May 7, 1997

Docket No. 50-366

HL-5389

**Edwin I. Hatch Nuclear Plant - Unit 2  
Supplemental Information Regarding the  
Inservice Inspection of Feedwater Sparger**

FIGURE 1

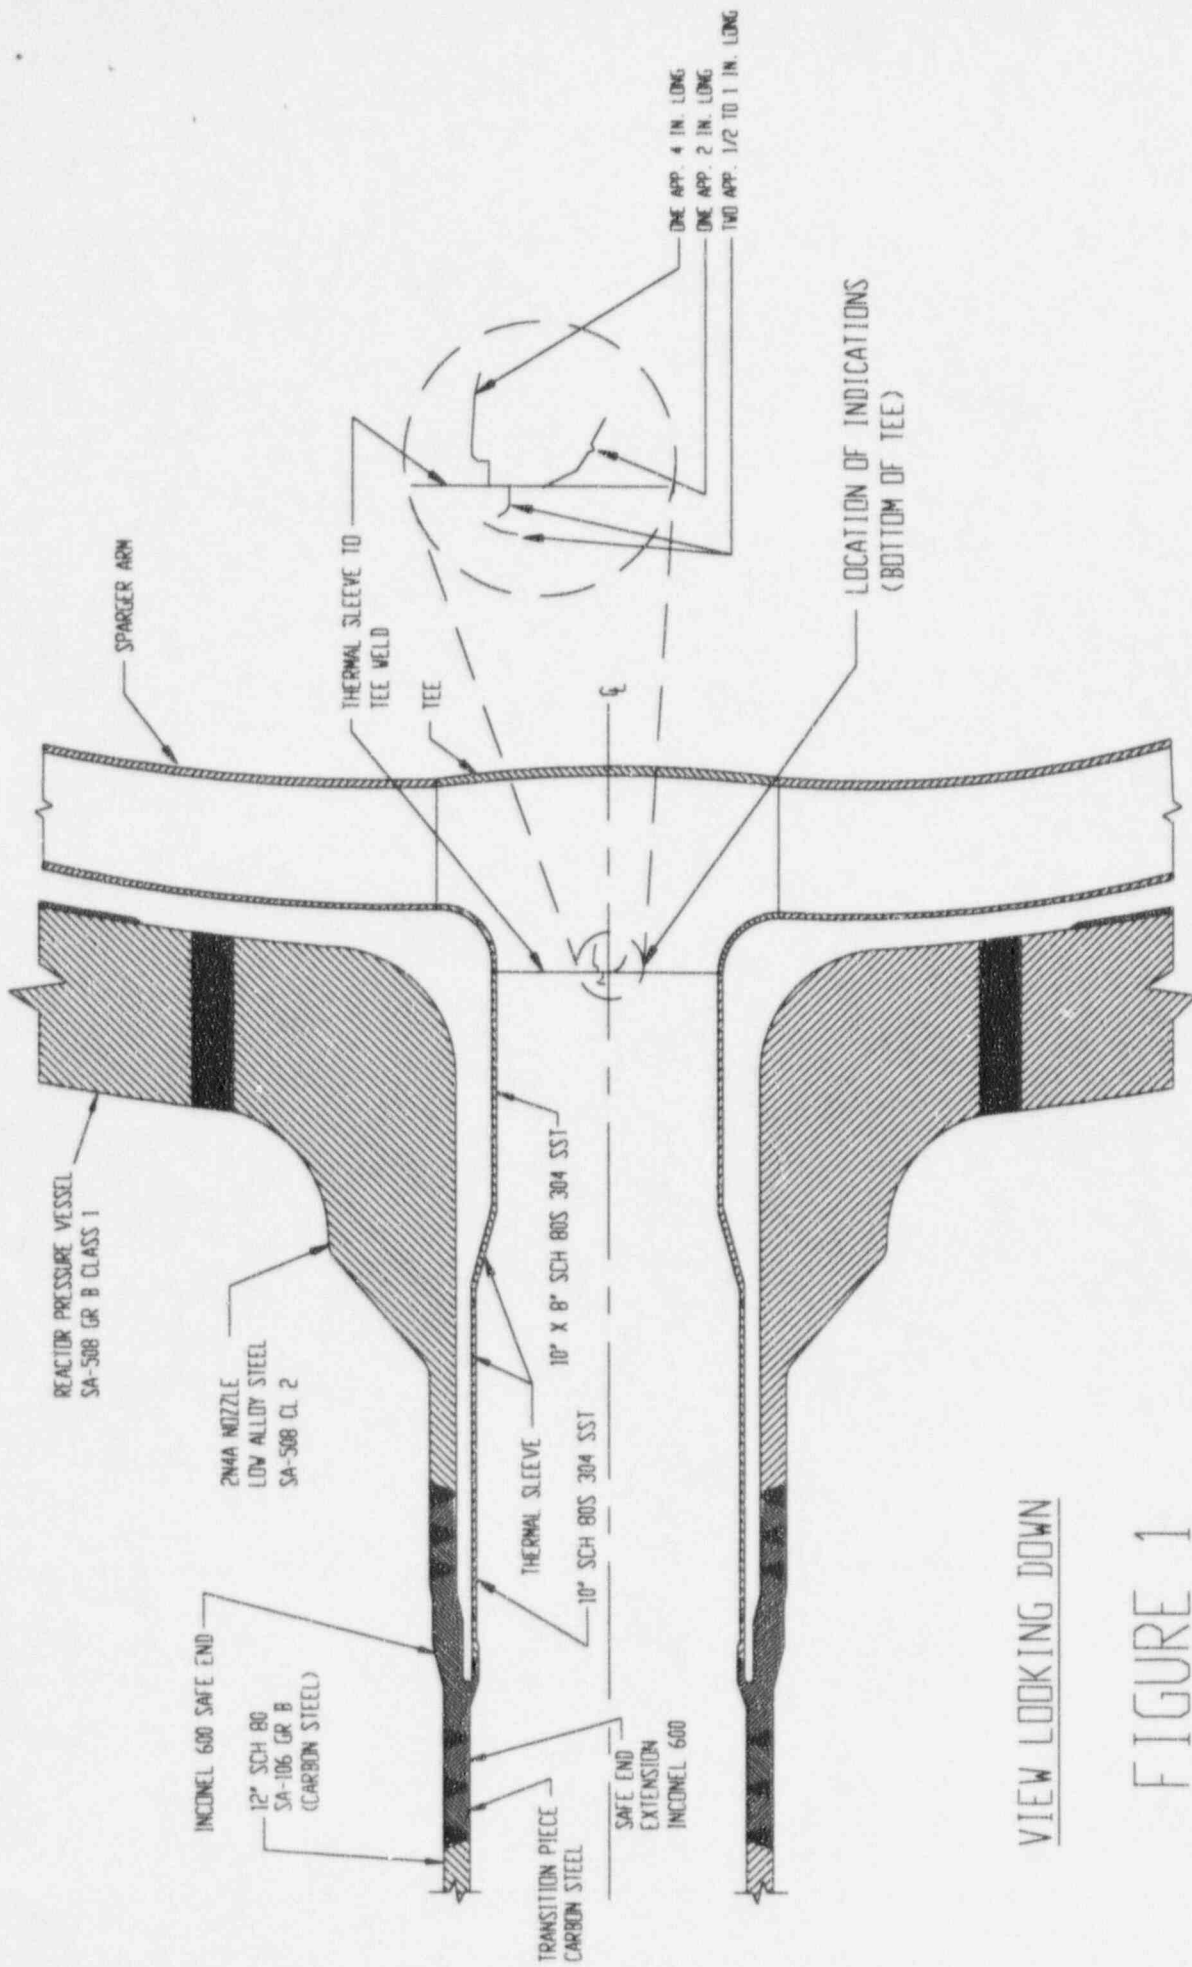
During a telephone conference call on April 28, 1997, the Nuclear Regulatory Commission (NRC) staff requested supplemental information regarding the characterization of the indications on the thermal sleeve and the potential for loose parts.

In response, Figure 1 provides additional details for the location of the indications on the 'A' sparger thermal sleeve. The indications are located on the bottom of the pipe and are predominately axial in orientation. A review of the examinations shows that the indications are characterized as four primary indications with minor branching. One indication is approximately four inches long and appears to traverse the sleeve to the tee weld. Another indication is approximately two inches long within the sparger tee next to the tee weld. The two remaining indications are approximately one and one-half inches long within the thermal sleeve next to the tee weld.

The predominately axial orientation of the indications, along with very low pressure and forces transmitted to the area of the indications, supports the determination that fatigue is the likely mechanism of the cracking. The relatively straight segments of the indications going through the tee weld are not characteristic of intergranular stress corrosion cracking (IGSCC). Additionally, the cracking at the observed locations would be expected to be circumferentially oriented rather than axial for causes other than fatigue.
